**From:** [Dan Masterpole](#)  
**To:** [Ketty Clow](#)  
**Subject:** FW: NSW Study Report  
**Date:** Monday, January 6, 2020 4:10:04 PM  
**Attachments:** [BolandSeep \(1\).pdf](#)  
[BOLAND STAHL 2019 Comments Final Oct 2019 \(1\).docx](#)

**From:** Katherine Stahl [mailto:stahland@centurytel.net]  
**Sent:** Sunday, November 03, 2019 6:53 PM  
**To:** Dan Masterpole; Ethan Hau  
**Subject:** NSW Study Report

We have reviewed the Northern Sands Wisconsin September 13, 2019 submittal for Permit #2015-1 which they claim to be a clarification response to your letter of August 7, 2019. It is our understanding that you have accepted their clarification. We would like to point out inaccuracies and deficiencies in their report and respectfully request you reconsider your acceptance.

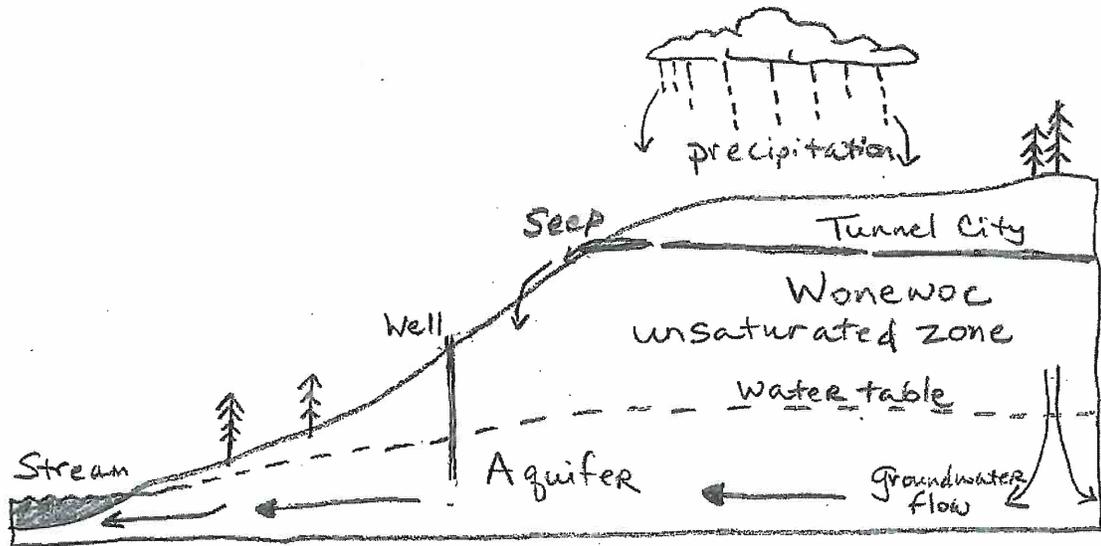
This sketch shows precipitation that infiltrates and creates a seep along the valley wall. The water from the seep re-infiltrates into the unsaturated zone, where it may recharge the water table or be used by plants. Clay-rich sediment within the Tunnel City Formation leads to the presence of seeps on the hillslopes. The stream is fed by groundwater. As the water table rises and falls seasonally, the headwaters of the stream will move, too. The headwater will be at higher or lower elevations, coincident with the water table. Wells are drilled into the saturated zone, or aquifer.

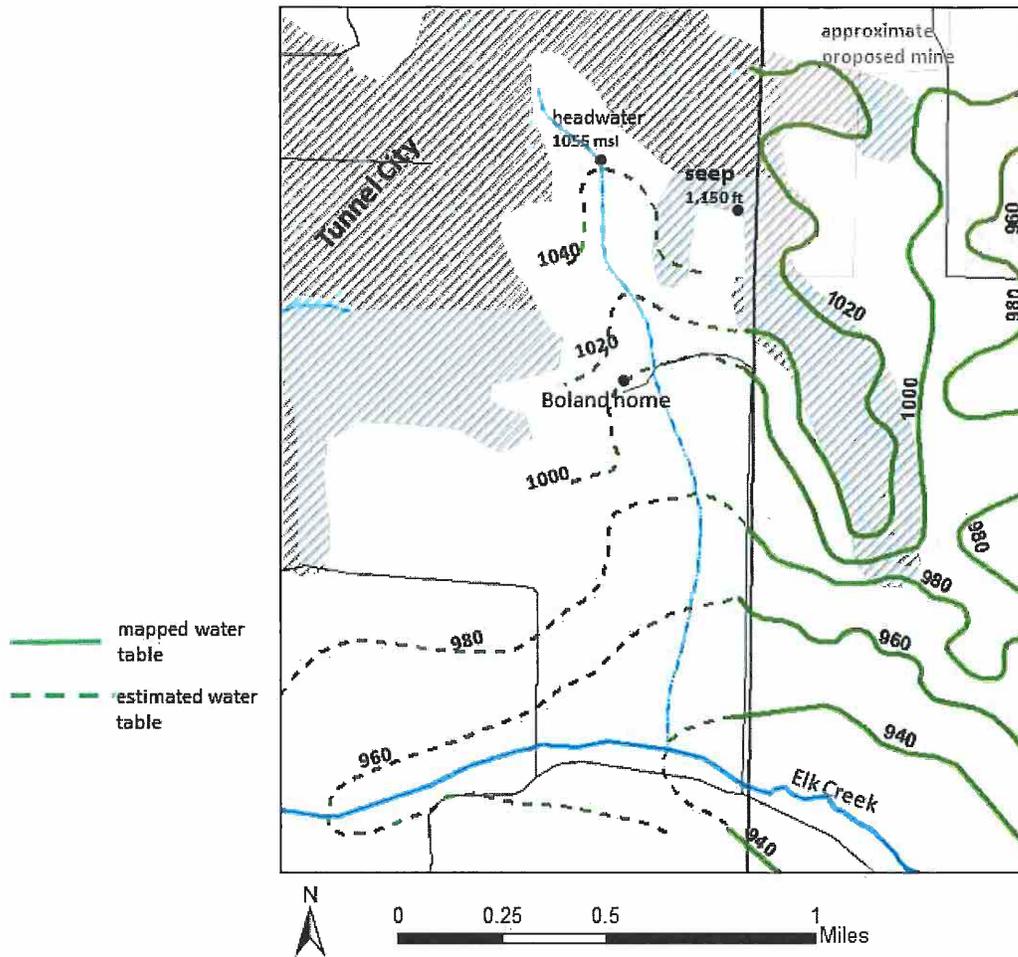
This sketch illustrates the estimated water table elevation near the Boland Home. The headwater of the stream reflects the water table elevation at that location. The seep is much higher in elevation, about 100 feet higher than the water table.
